NUCLEAR REGULATORY COMMISSION

MEETING TOPIC: SOURCE TERM PROGRAM

Stone & Webster Engineering Corporation
Boston, Massachusetts

SOME COMMENTS ON NUREG-0956 (DRAFT) ANALYSIS OF AB-B SEQUENCE

SURRY 2 CONTAINMENT
SECTION VIEW NO. 3

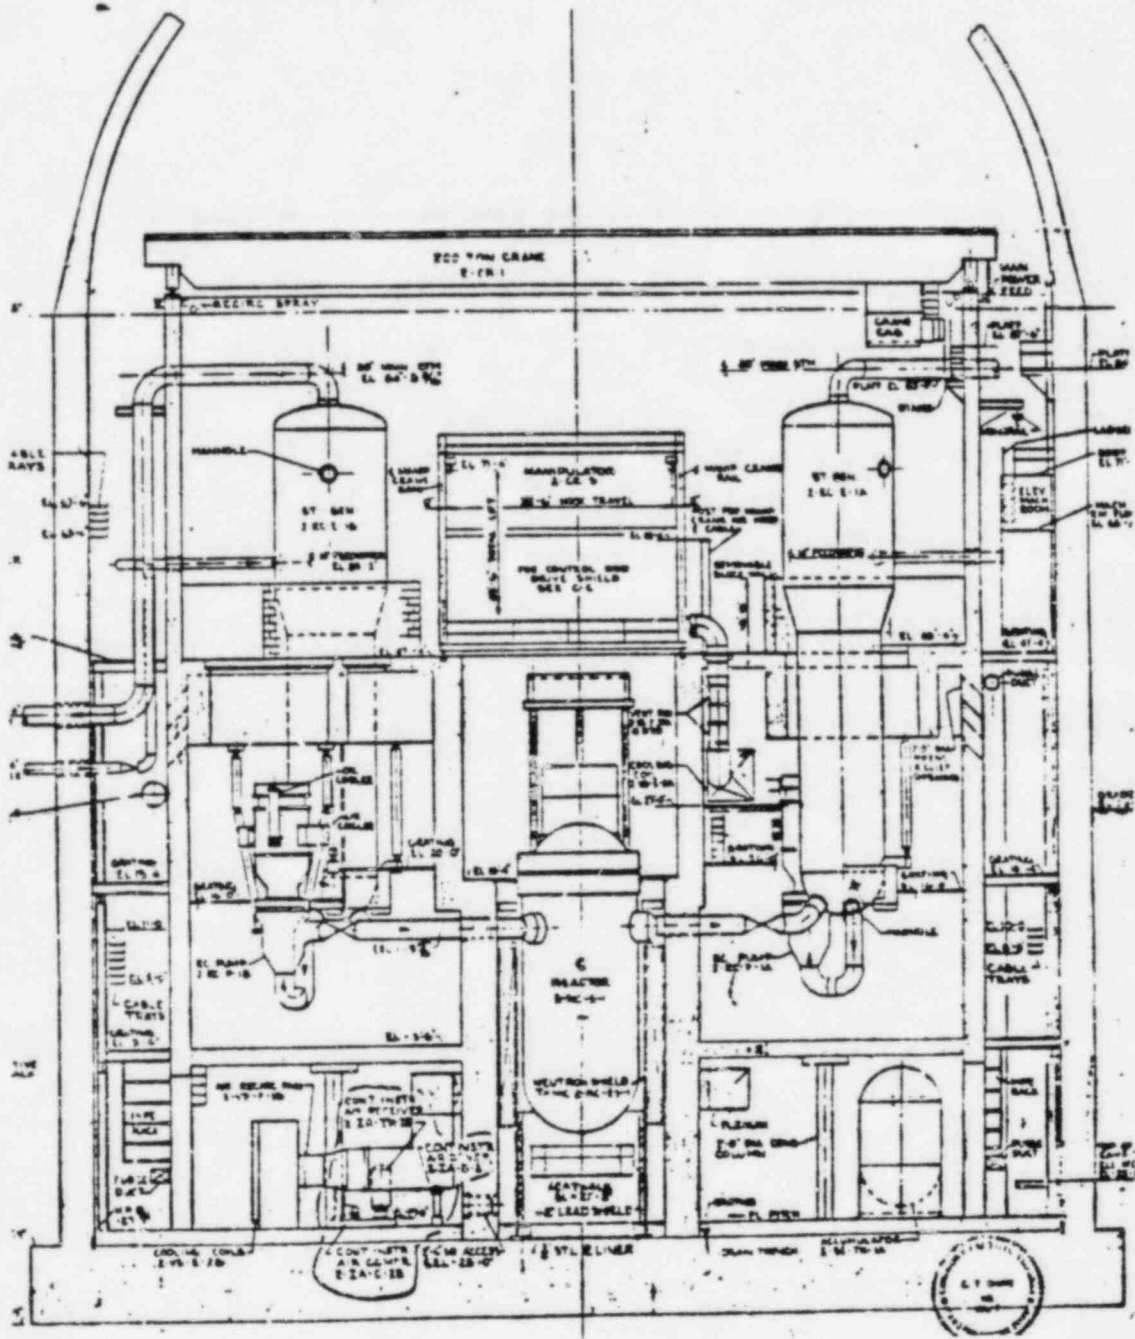
- o A single node containment model is grossly unrealistic and does not lead to best estimate releases.
 - During the period from start of core melt to core slump (i.e. 27 to 80 min), releases via the hot leg break would be into the steam generator compartment with a subsequent restrictive release path involving additional containment nodes.
 - Releases after pressure vessel meltthrough would be via three separate toaduous flow paths as follows: 1) In-core instrumentation tunnel, 2) Lower and upper reactor cavity, and 3) the RCS and steam generator compartment, with the majority of the aerosol flow expected to be via the in-core instrumentation tunnel.
- o The unisolated containment penetrations lead into contiguous buildings (e.g. auxiliary or safeguards buildings) or filter systems. Multinode modeling of the subcompartments in these buildings is required.

SWEC PRELIMINARY MULTINODE MODEL

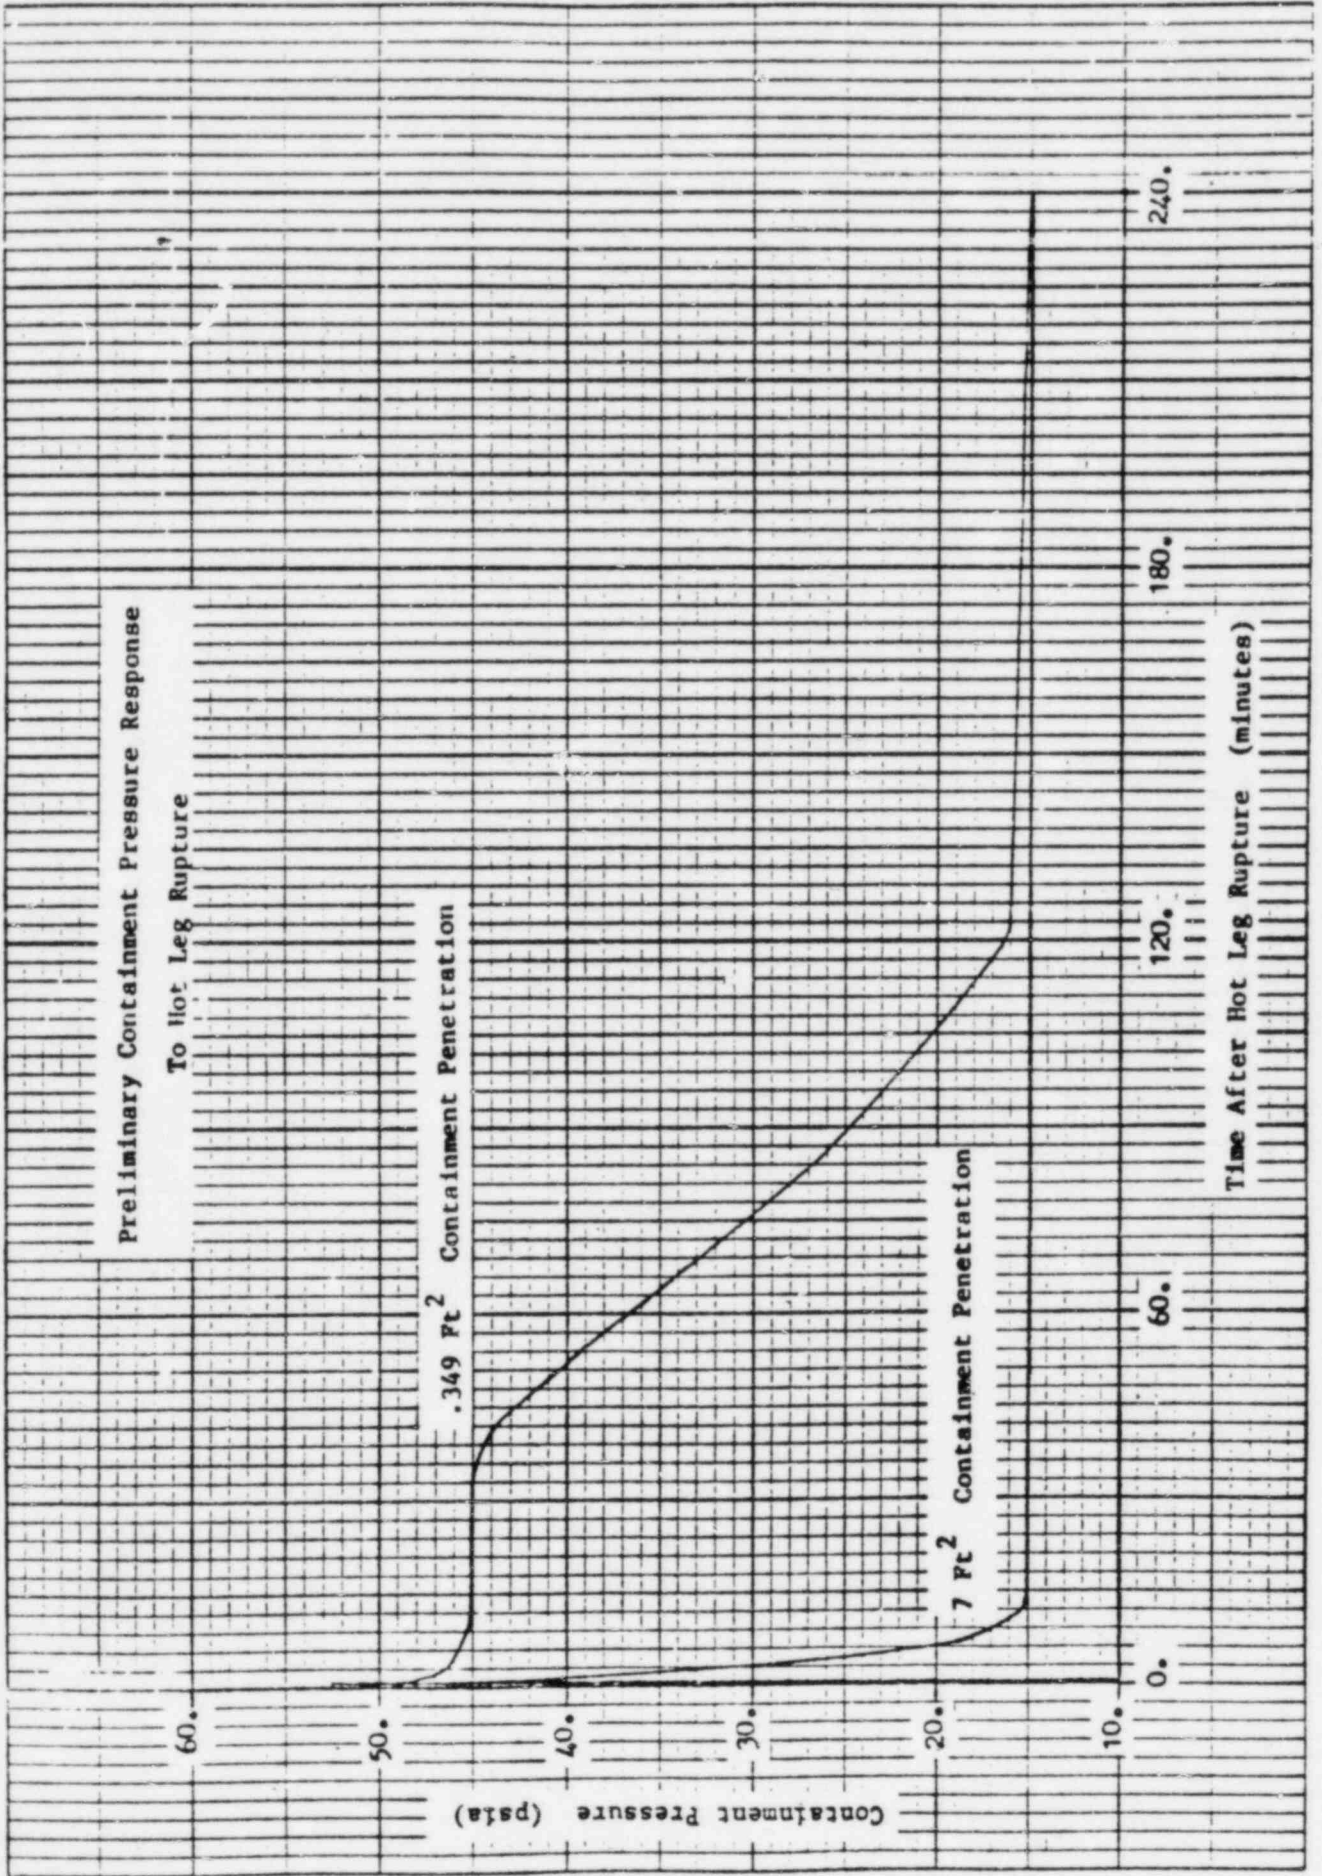
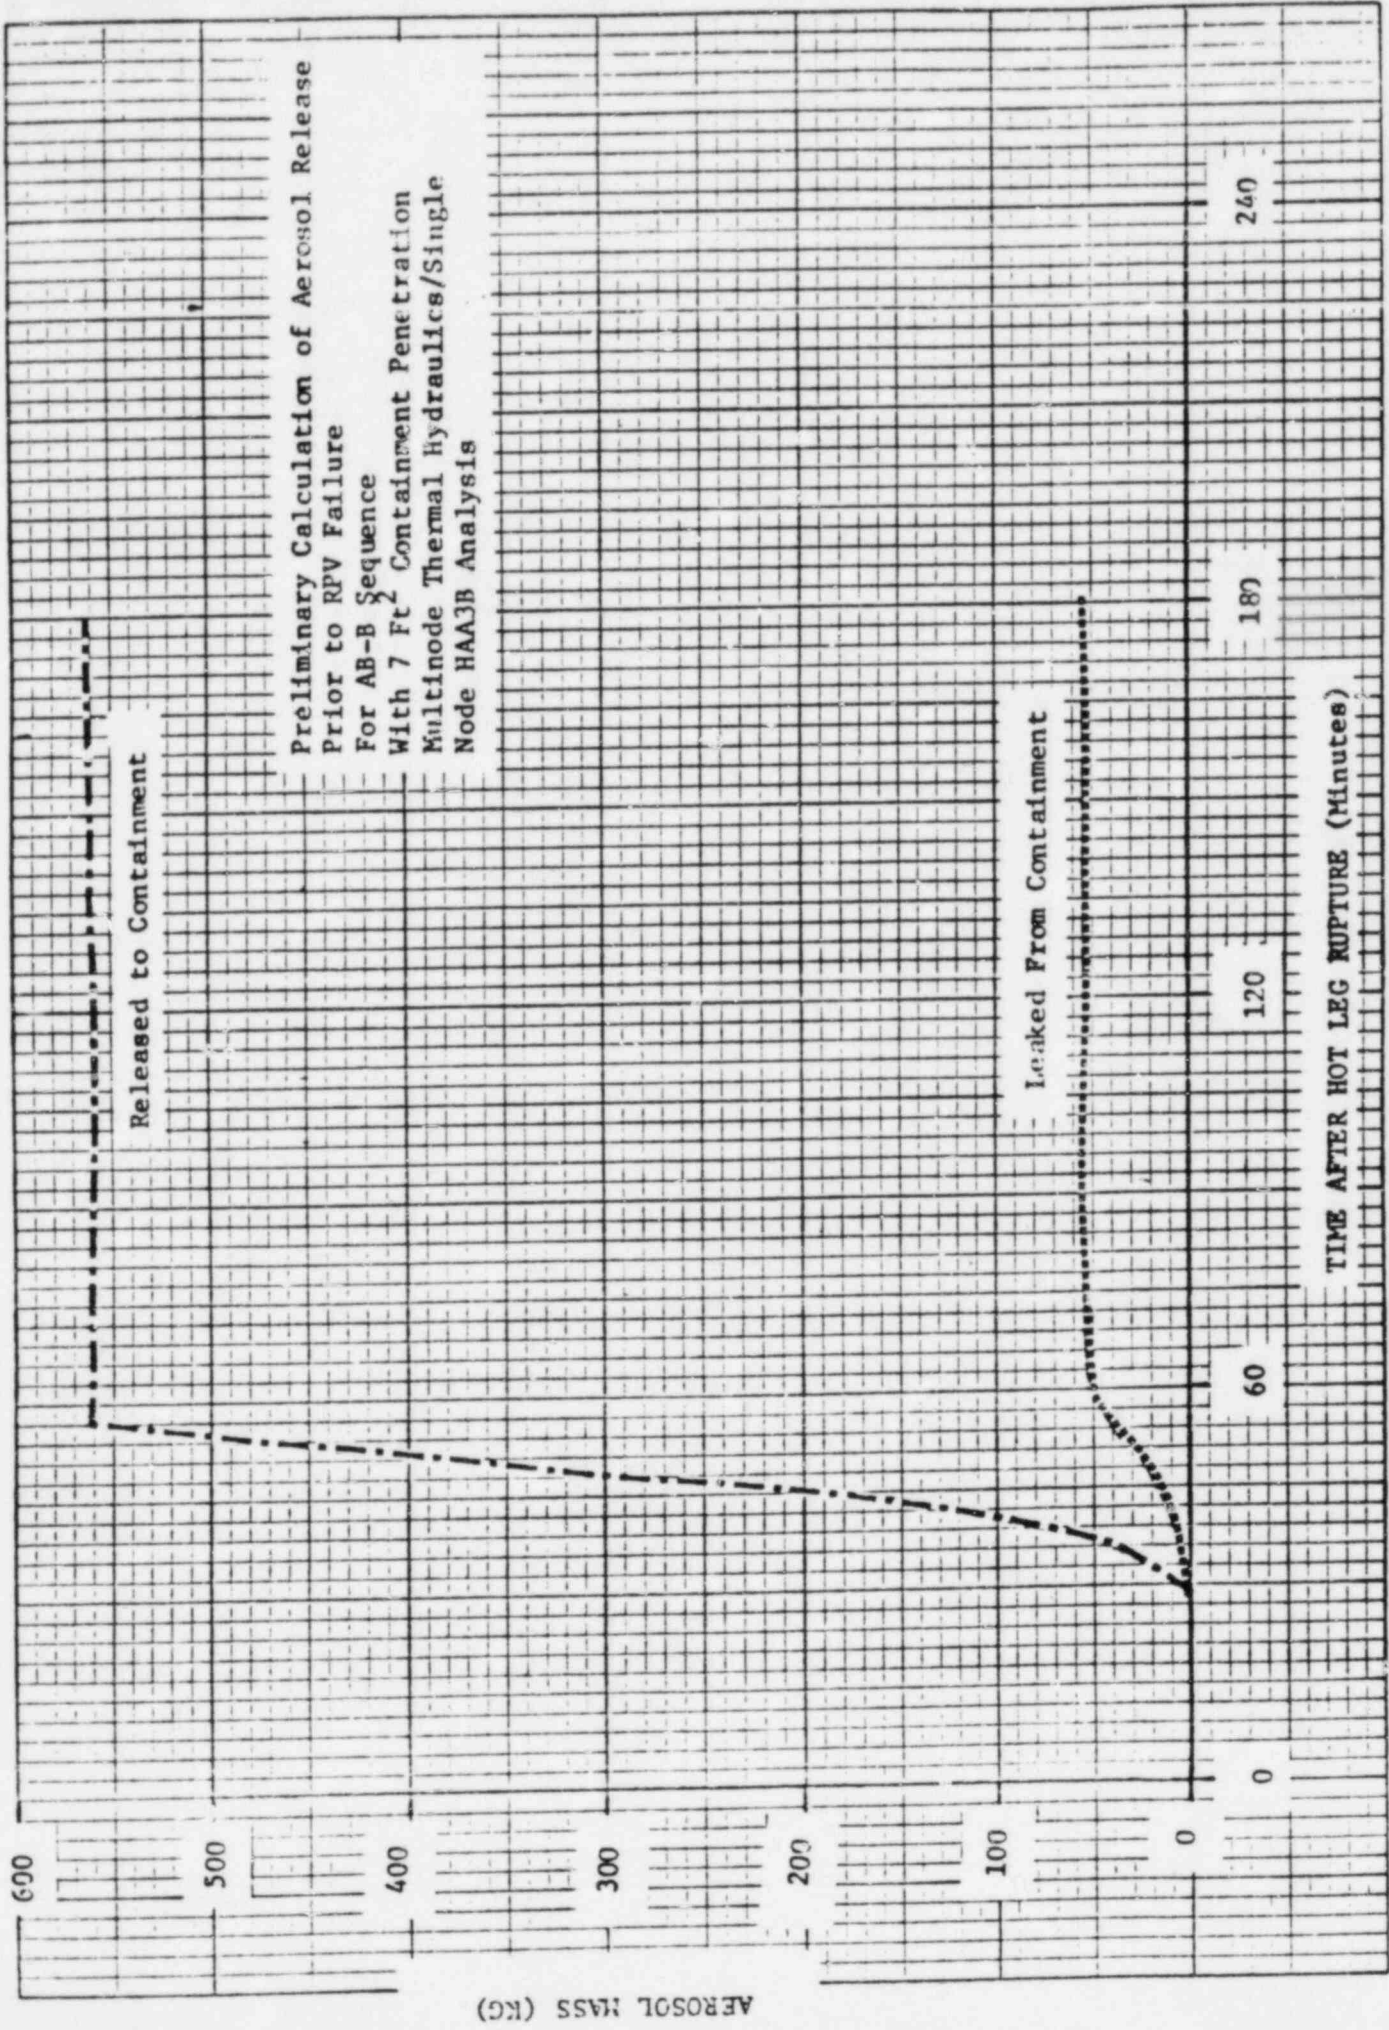
- o A multinode model is required for: 1) the reactor vessel internals, 2) the RCS piping, 3) the smaller diameter ECCS piping, and 4) subcompartments in the auxiliary building. This model should include right angle bends and the T connections from the RCS to ECCS.
- o The assumption that all flow goes back through the RCS after vessel meltthrough is unrealistic. A multinode model of the reactor cavity and in-core instrumentation tunnel flow paths is required, including appropriate flow splitting.
- o Flow splitting into depressurized piping within the RCS must be realistically accounted for.
